SOLLIE OAKS SUBDIVISION

APPLICATION NUMBER 16 DATE April 17, 2003
APPLICANT Sollie Oaks Subdivision
REQUEST Subdivision

DETAIL SITE PLAN

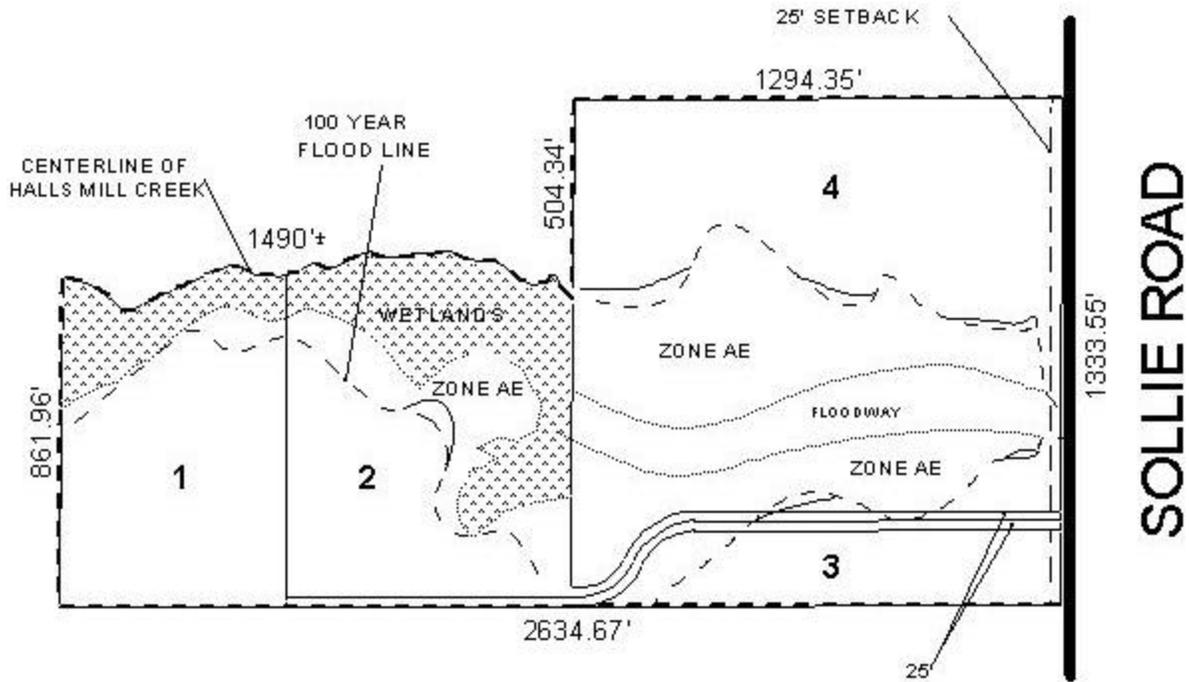
The plat illustrates two-flag shaped lots, which are characteristic along a waterway; moreover, the buildable area of the two flag lots is reduced by the wetlands and flood zones crossing the property.

The site fronts Sollie Road, a planned major street, and the dedication of adequate right-of-way is provided; and as a means of access management, Lots 3 and 4 should be limited to one curb cut each to Sollie Road. It should be noted the proposed Girby Road Extension embraces a portion of Lot 4 and as such the provision of an adequate setback to provide for the future right-of-way of the planned major street should be required. Additionally, as Lots 1 and 2 have only 25-feet of street frontage, these lots should be required to share one common curb cut to Sollie Road.

With modifications and a waiver of Section V.D.3. (width to depth ratio), the plat will meet the minimum requirements of the Subdivision Regulations and is recommended for Tentative Approval subject to the following conditions: 1) the dedication of the necessary right-of-way to provide 50-feet from the centerline of Sollie Road, a planned major street; 2) placement of a note on the final plat stating that Lots 3 and 4 are limited to one curb cut each to Sollie Road; 3) placement of a note on the final plat stating that Lots 1 and 2 are required to share one common curb cut to Sollie Road; 4) provision of an adequate setback to provide for Girby Road Extension (including the required 25-foot building setback); and 5) placement of a note on the final plat stating that if any property is developed commercially and adjoins residentially developed property, a buffer in compliance with Section V.A.7. will be provided.
